Sydney Metro West

Sydney Olympic Park Over and Adjacent Station
Development

Addendum to Appendix Y - Flooding Assessment

Document Number: SMWSTEDS-SMD-OLP-SN400-WA-RPT-044003

TITLE
 Stage 1 Detailed Design
 PMF Developed Flood Depth

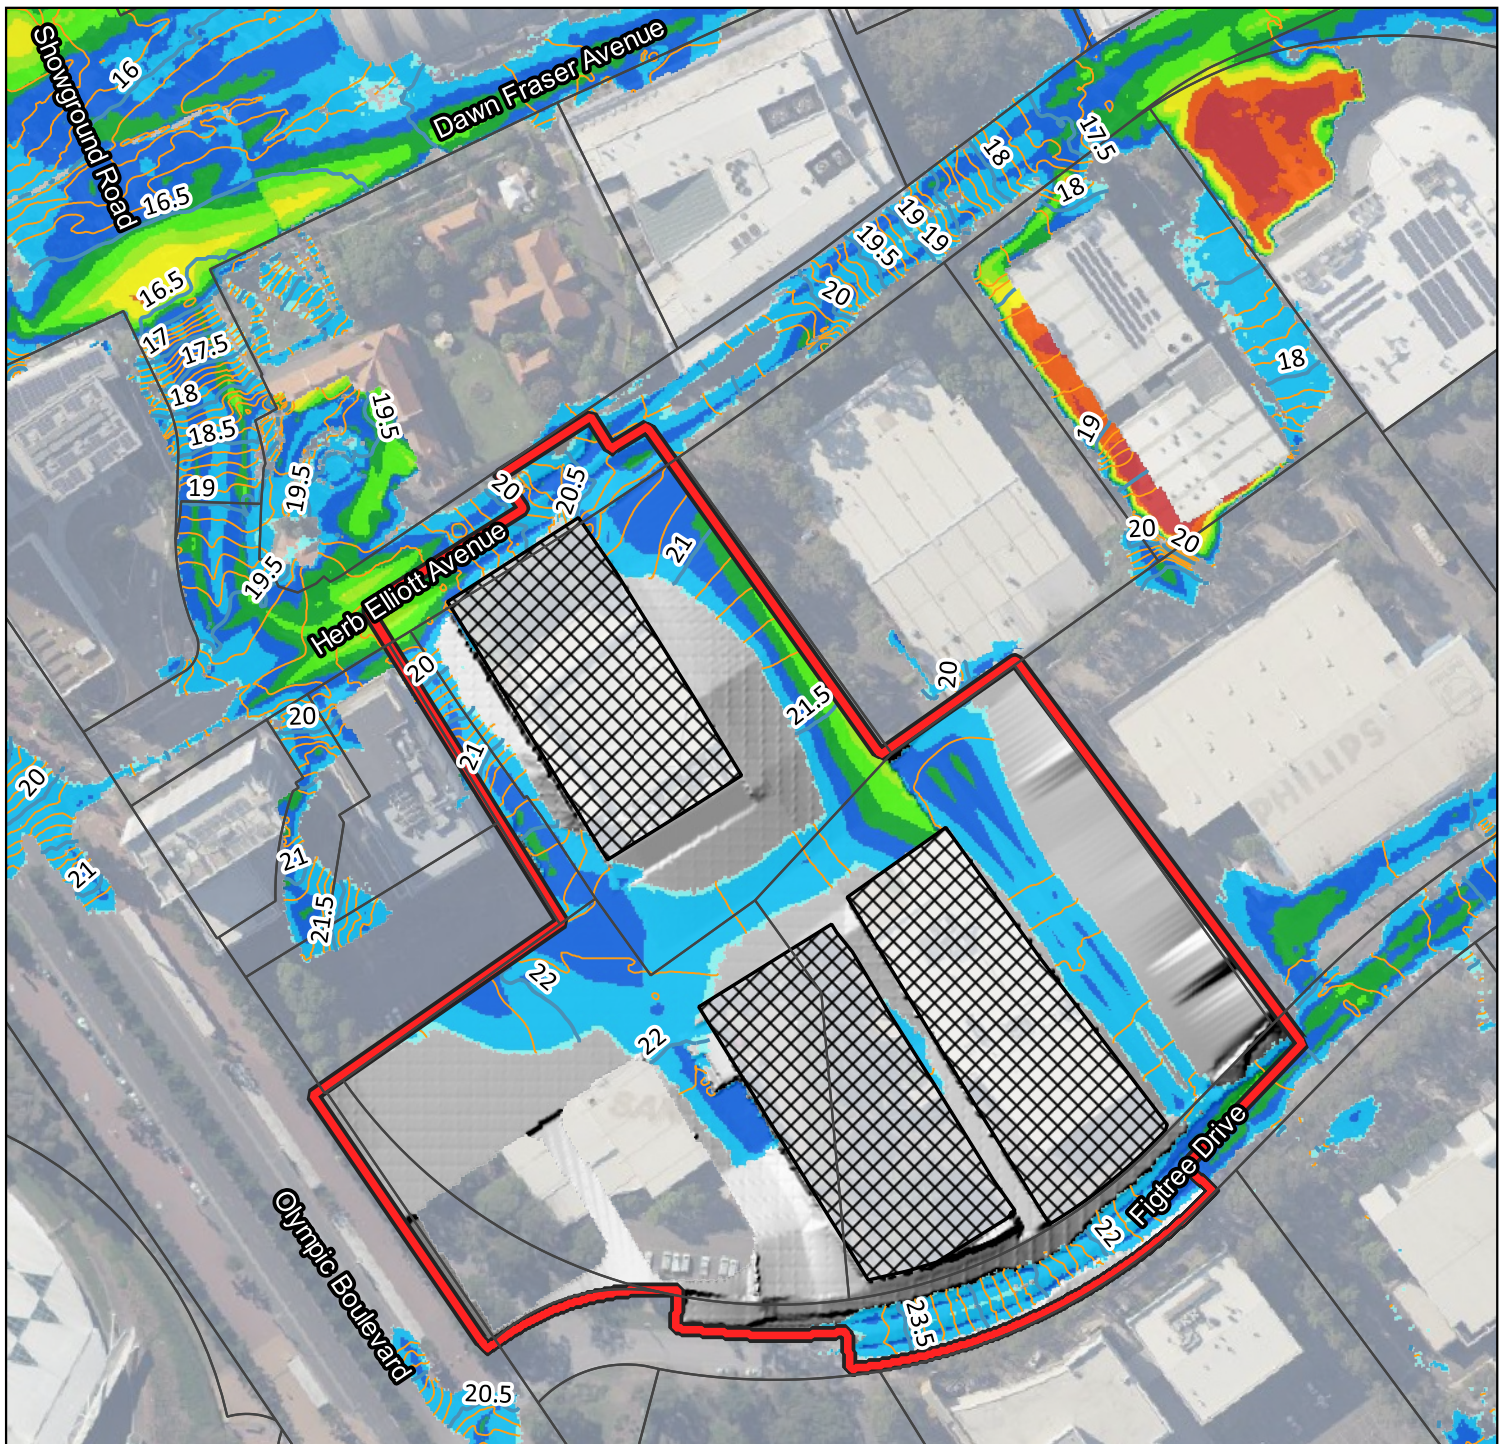
Agency advice	Response
<p>The modelling shows flooding in a PMF event in Figtree Drive at the east of the site, at the intersection with Precinct Street A. The modelling indicates depths of 0.1-0.2m and 0.2-0.3m, which would limit access to and evacuation from Precinct Street A. EHG recommends that the main driveway entry be in Figtree Drive, to the west of this flooding to enable access in all flood events.</p>	<p>In the PMF event, Figtree Drive at the intersection with Precinct Street A experiences hazard category H1 with flood depths of up to 0.31m. Given the maximum flood depths are at the limiting still water threshold for this hazard category, it is noted that hazard category H2 is not considered safe for small vehicles.</p> <p>Consequently, horizontal evacuation from the precinct to Figtree Drive via Precinct Street A may not be safe in all circumstances. On that basis and in the context of the current design, it is noted that other options exist for evacuation including:</p> <ul style="list-style-type: none"> • evacuation by foot through the Promenade and onto Figtree Drive (H1 category areas) • evacuation by foot through the Sydney Olympic Park metro station public areas onto Precinct Street B to access Figtree Drive (H1 category areas) • sheltering in place within an over station or adjacent station development. <p>As outlined below in this table this matter would be considered further by the Detailed SSDA.</p> <p>Whilst not a matter for this application, it is</p>

Agency advice	Response
	<p>noted that the conditions of approval for the Stage 3 CSSI application require the development of operational emergency management plans for flooding. Consequently, it is expected that those arrangements would consider relevant matters such as the preferred evacuation arrangements for this metro station. This potentially presents further option(s) which may be considered by the Detailed SSDA.</p>
<p>EHG further recommends consultation with the SES regarding emergency management. If Precinct Street A is used as the main vehicular access, Buildings 2 and 3 will not have flood free access in all flood events, contrary to the reporting.</p>	<p>Although under the current design, horizontal evacuation by vehicle from the precinct may not be safe in all circumstances, there are alternative evacuation options. Resolution of the preferred evacuation arrangements would be best addressed during future stages of design, which would include the Detailed SSDA, as there are several approaches to addressing this risk. They are:</p> <ul style="list-style-type: none"> • Amending the design to reduce flood risk to occupants and address remaining flood risk in the operational flood emergency response plan • Incorporating shelter-in-place arrangements into the operational flood emergency response • Coordinating with the Sydney Olympic Park metro station operational emergency management plan for flooding. <p>The NSW Government undertook consultation on draft shelter-in-place guidelines in January 2023. It is recommended that if the proposal includes shelter-in-place arrangements to address flooding risk that they are consistent with the requirements of the Draft Shelter-in-place Guideline unless the NSW Government has formally adopted Shelter-in-place Guidelines. Under the Work Health and Safety Regulation 2017, a person conducting a business or undertaking has a duty to prepare, maintain and implement an emergency plan. This would apply to the over and adjacent station development unless they were specifically excluded. The regulation specifies the matters to be covered in the emergency plan including emergency and evacuation procedures.</p> <p>The Emergency Management Supporting Plan for Sydney Olympic Park (policy no POL11/11) applies to owners and operators of premises within Sydney Olympic Park. It requires that control and co-ordination of emergency response are initially conducted at the lowest effective level. Therefore</p>

Agency advice	Response
	<p>developer(s) of the over and adjacent station development proposal would need emergency plans for flooding in the case that residual flood risk exists at the completion of design.</p> <p>However, should an emergency be beyond the scope of the building management then the policy requires that assistance is sought from the relevant combat agency. As the NSW SES are the combat agency for flooding it is recommended that developer(s) of the over and adjacent station development proposal consult with the NSW SES when developing their respective emergency plans for flood events to ensure consistency with broader emergency arrangements.</p>
<p>Review the advice of DPE's Environment and Heritage Group and revise the proposal to support flood modelling and evacuation</p>	<p>The advice has been considered. Additional commentary in the table above responds to the specific agency comments regarding evacuation arrangements associated with the current design. Two additional mitigation measures have been proposed to ensure that future design stages consider relevant NSW Shelter-in-place Guidelines and require consultation with the NSW SES regarding emergency management. It is expected that these matters would be fully addressed in the future Detailed SSDA.</p> <p>The addendum to Concept SSDA EIS Appendix X – Preliminary Integrated Water Management Report discusses how agency advice regarding biodiversity and the Northern Water Feature have been addressed. However, it is noted that flood modelling is consistent with relevant SOPA guidelines.</p>

TITLE
 Stage 1 Detailed Design
 PMF Developed Flood Hazard

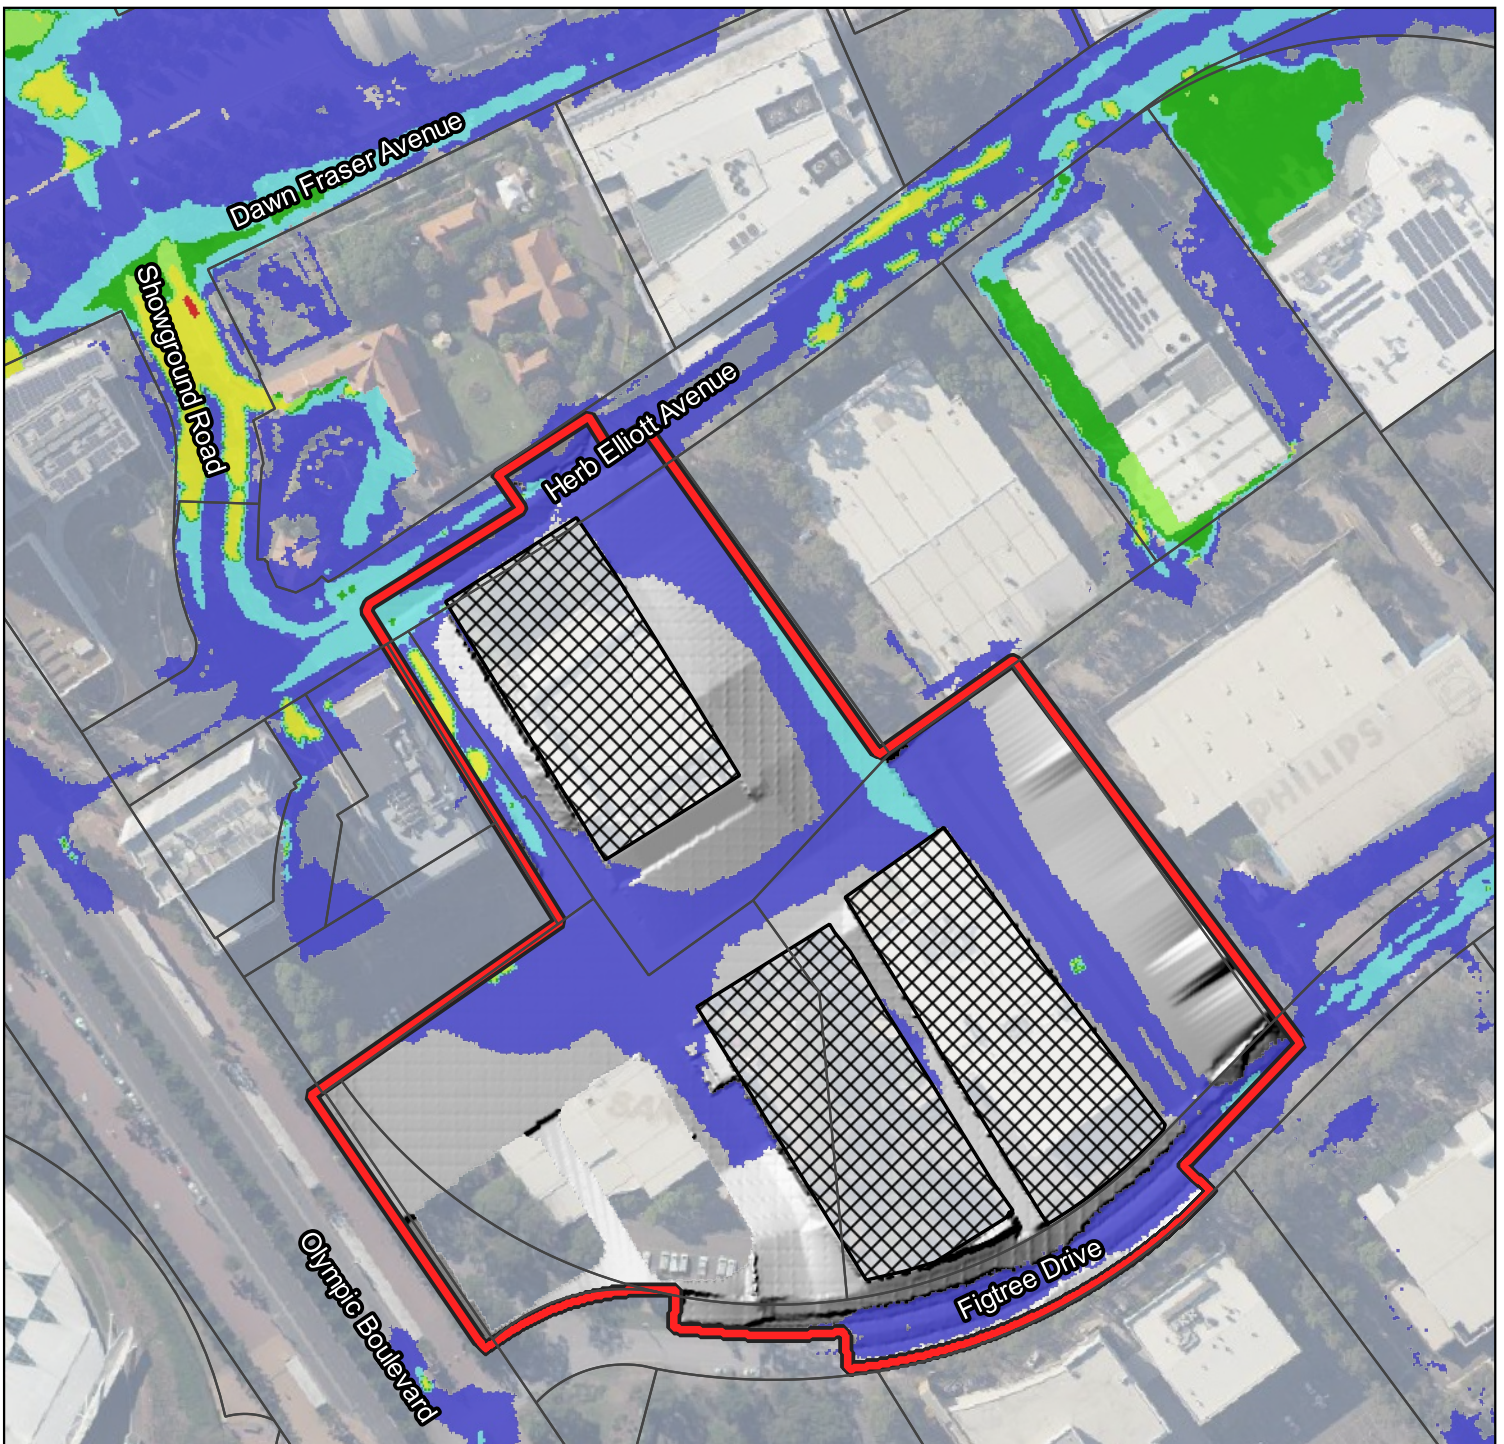
Flooding	EHG further recommends consultation with the SES regarding emergency management. If Precinct Street A is used as the main vehicular access, Buildings 2 and 3 will not have flood free access in all flood events, contrary to the reporting.	Refer Table 3-1
